**Solicitation Name:** East Hamilton High Track & Field Event Site

**Subject:** Addendum Number 1

**MANDATORY PRE-BID MEETING  
EAST HAMILTON HIGH SCHOOL TRACK  
IMPROVEMENTS MARCH 23, 2023 @ 10:00 AM  
MEETING MINUTES/ADDENDUM 1**

SHEET NO. **C-3**

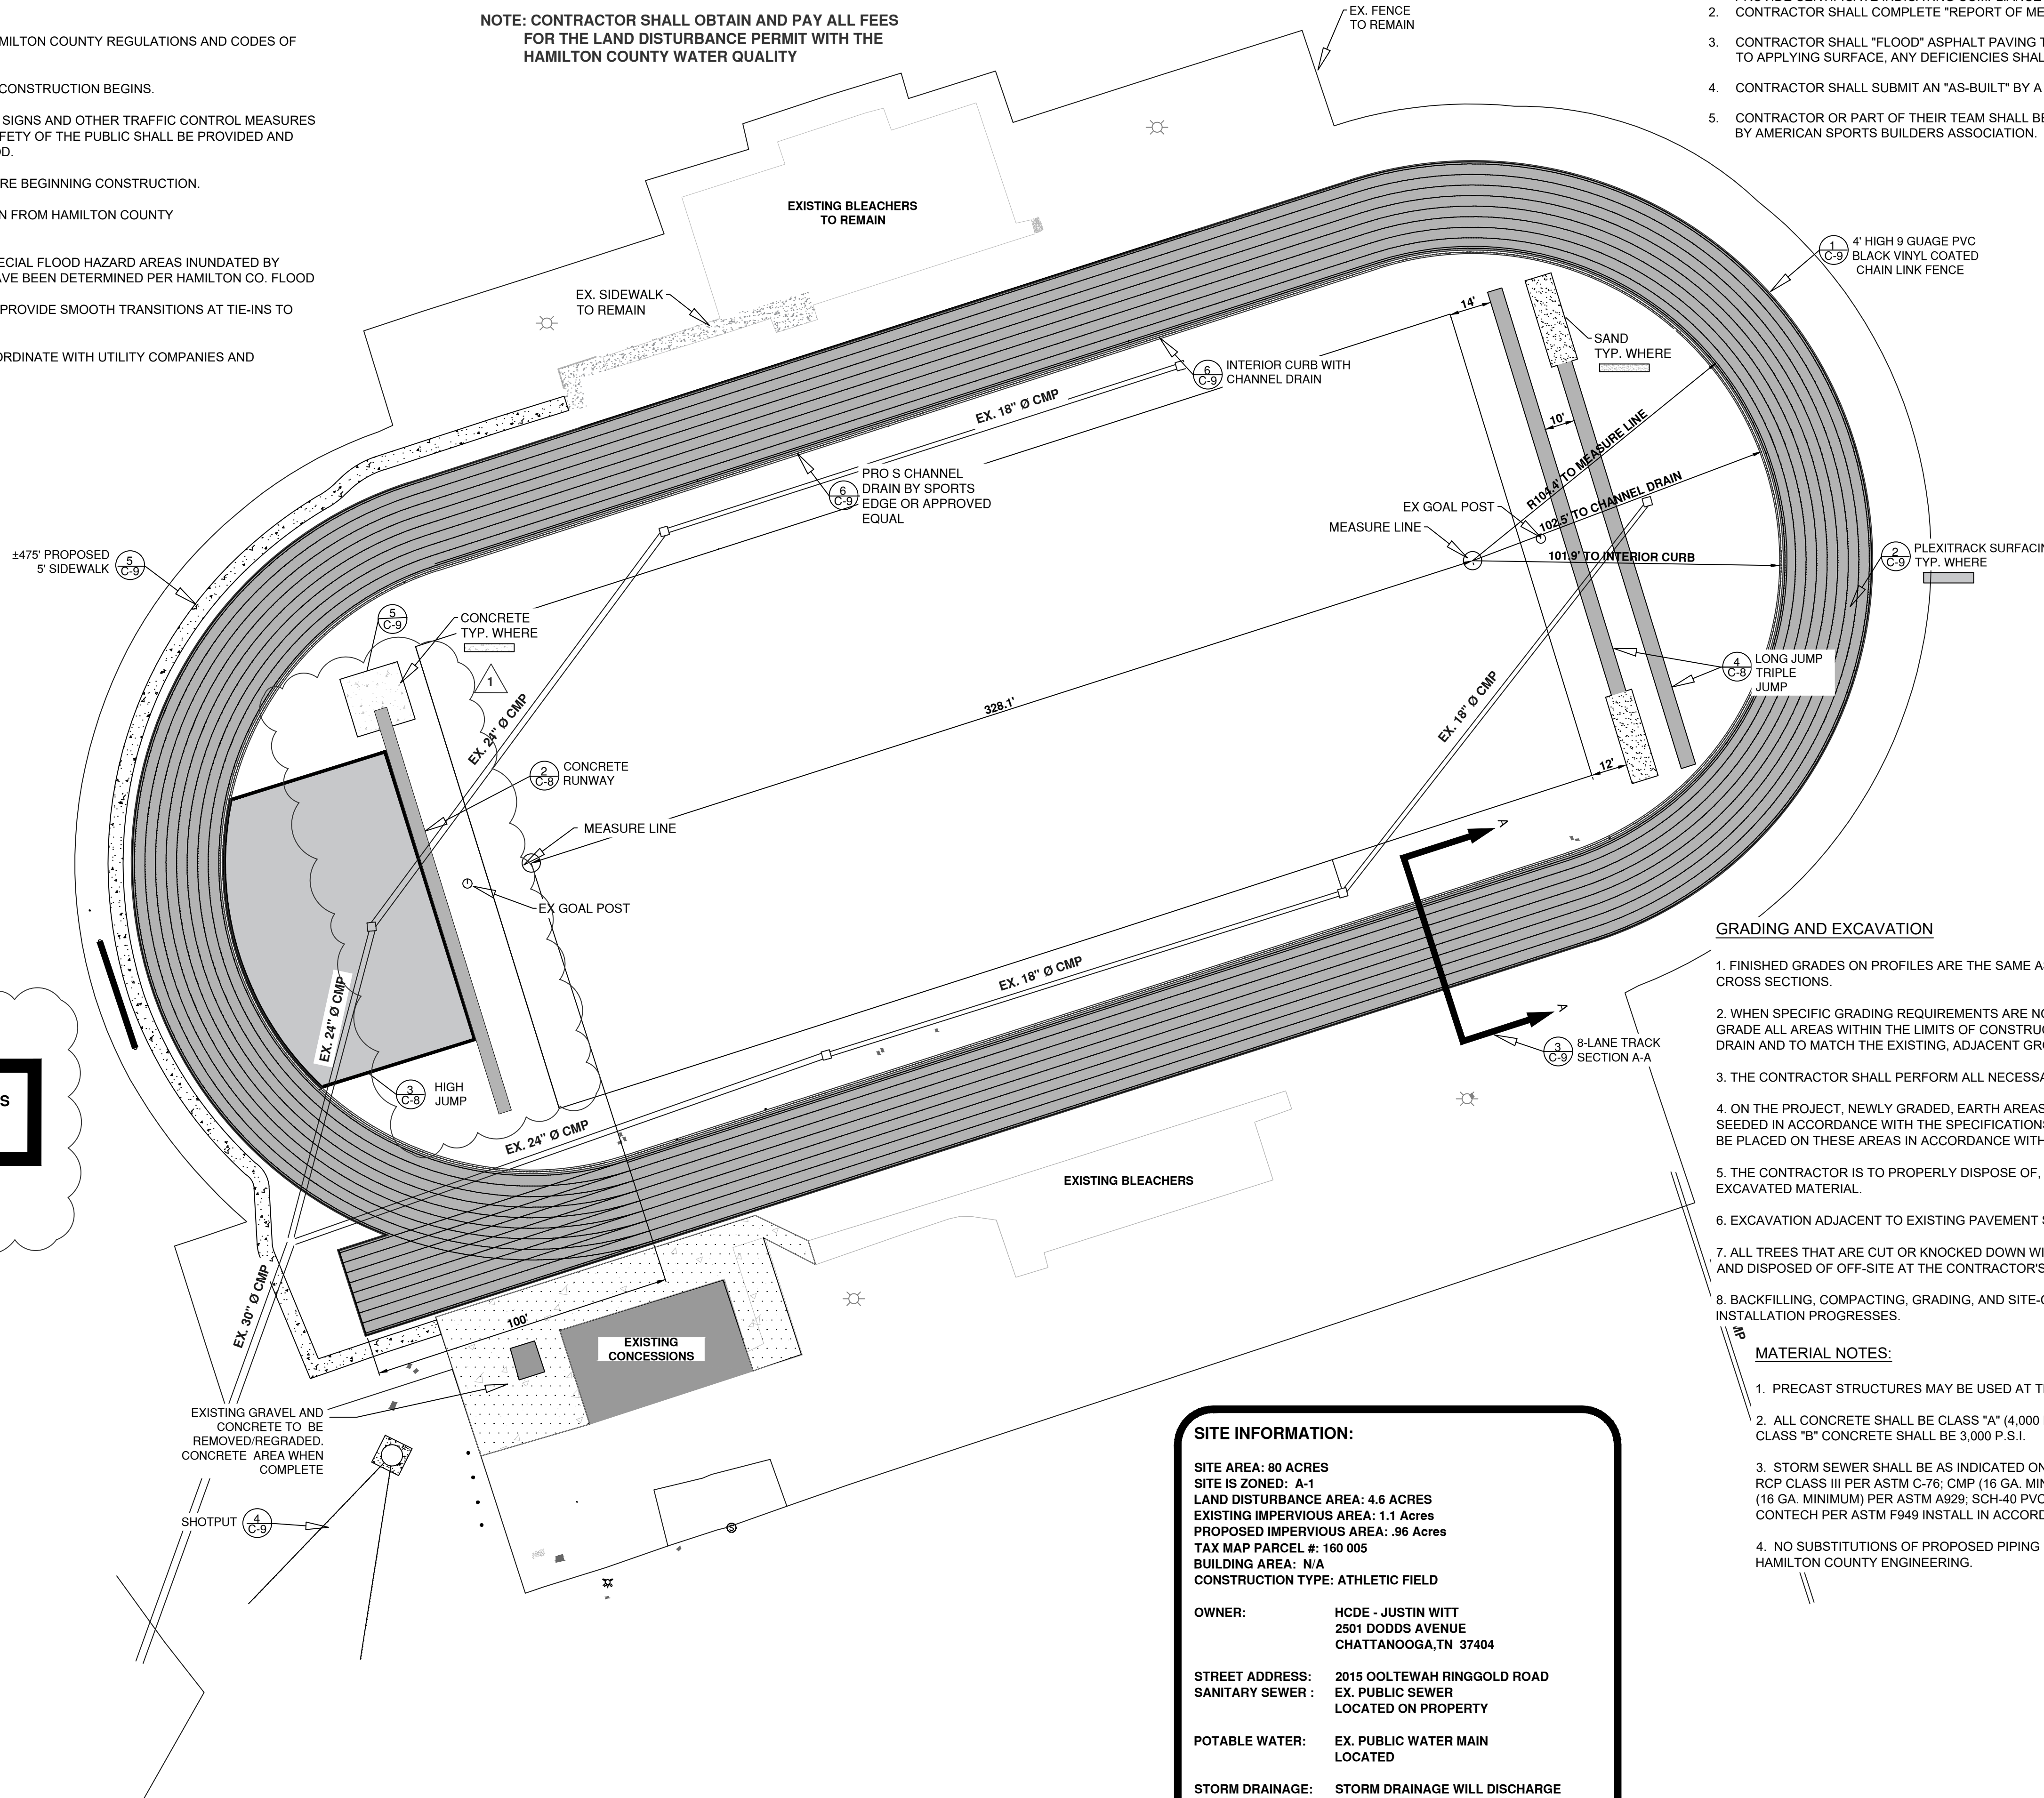
- Attendees were encouraged to visit the site.
- The discus event is being removed from the site plan; See Attached Plans
- Pole Vault location is being moved to the D zone are; See Attached Plans

NO.	DATE	DESCRIPTION	BY
1	03/15/23	ISSUED DISCUSS/ADD NOTE	NAG
1	03/15/23	REVISED PILE WALL TO D ZONE	NAG

SHEET NO. **C-3**  
PROJECT NO. 22-07-02.03

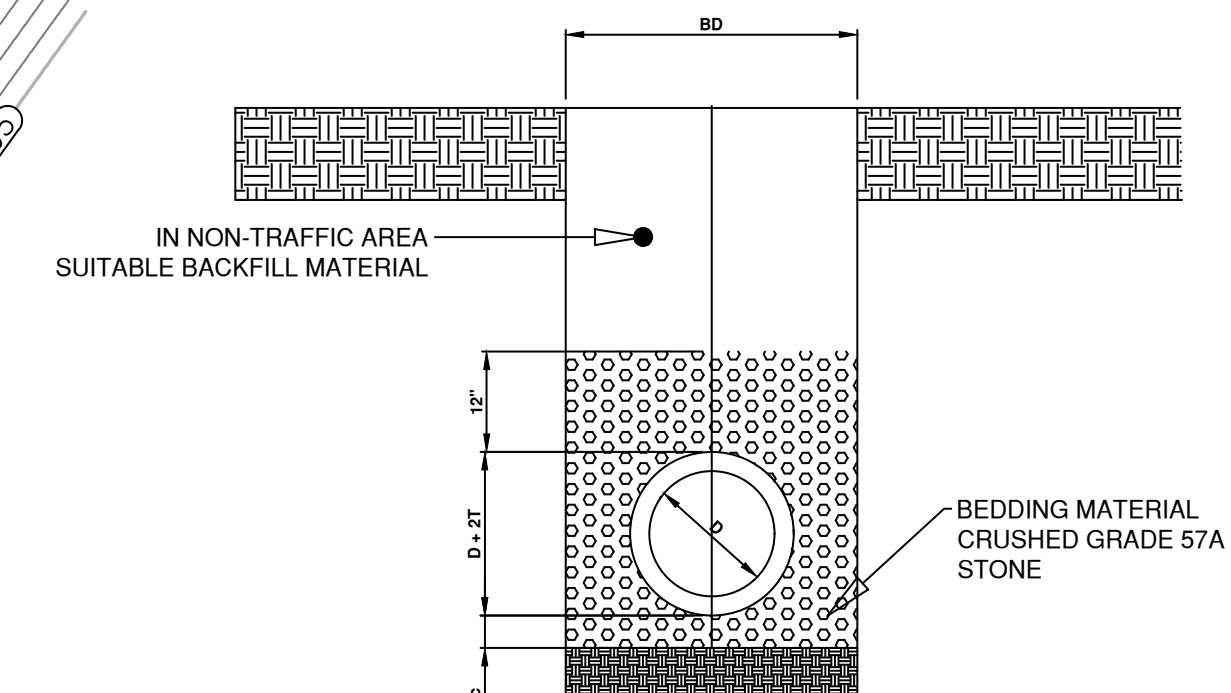
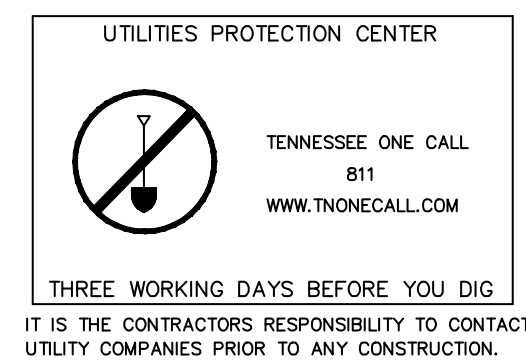
- Added inlet in D zone; See attached Plans
- Added note for plexitrack surface; See attached Plans
- See attached Pre-Bid Attendees.
- See attached GEO Report

NO.	DATE	DESCRIPTION
1	04/04/23	ADDED INLETS, MOVED POLE VAULT

2 TRACK SECTION  
C-9

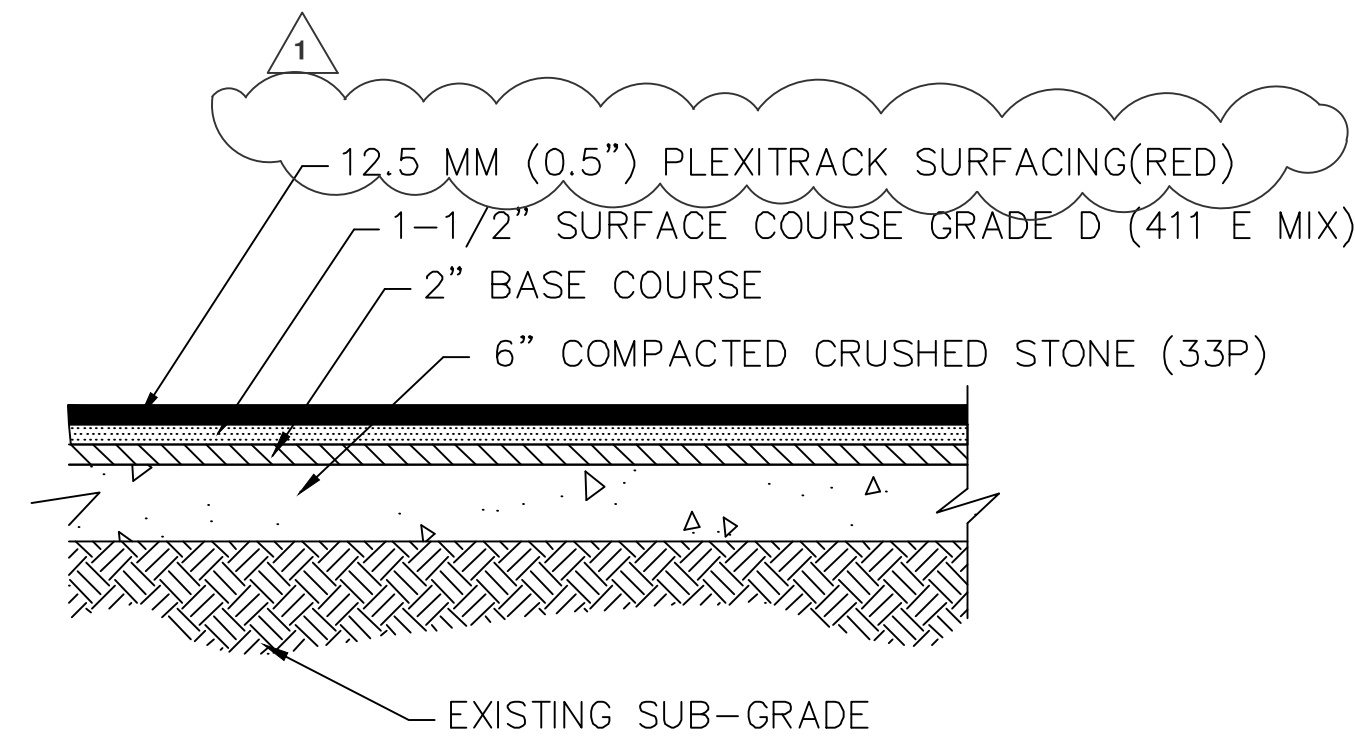
NO.	DATE	DESCRIPTION	BY	ING
1	03/15/23	CHANGED PLACEMENT OF PLEXITRACK SURFACING
